## PRODUCT/PROCESS CHANGE NOTICE (PCN)

<b>PCN #:</b> <b>A1303-05</b> <b>Product Affected:</b> 3.0mm x 3.0mm VFQFPN-20 4.0mm x 4.0mm VFQFPN-24 4.0mm x 4.0mm VFQFPN-28 (Refer to Attachment 2)	<b>DATE:</b> <b>June 10, 2013</b>	<b>MEANS OF DISTINGUISHING CHANGED DEVICES:</b> <input type="checkbox"/> Product Mark <input type="checkbox"/> Back Mark <input type="checkbox"/> Date Code <input checked="" type="checkbox"/> Other <div style="margin-left: 20px;">           Assembly lot marked on the device provides traceability to the material used         </div>
<b>Date Effective:</b> <b>September 10, 2013</b>

### ATTACHMENT 1 - PCN # : A1303-05

**PCN Type:** Assembly Process and Material Change

Figure 1: Illustration of Interposer Inserted between top die and bottom die (Top View)

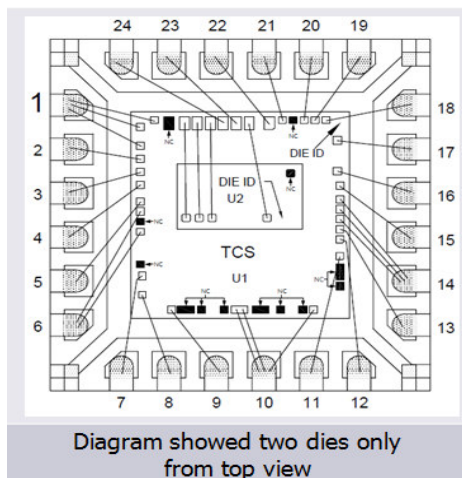
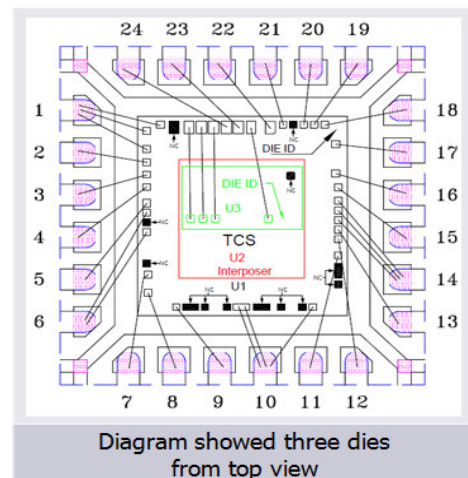
This notification is to advise our customers that IDT has successfully completed the qualification of stack die assembly with interposer. An interposer will be added in between the top die and the bottom die to improve assembly yield.

The die attach material for the top die will change to NEX-130SB-25 and for the bottom die to 8200T.

Description	Changes	
	From	To
Package Technology	Without Interposer	With Interposer (inserted between top and bottom die)
Die Attach (Top Die)	NEX130CT	NEX-130SB-25
Die Attach (Bottom Die)	8600	8200T
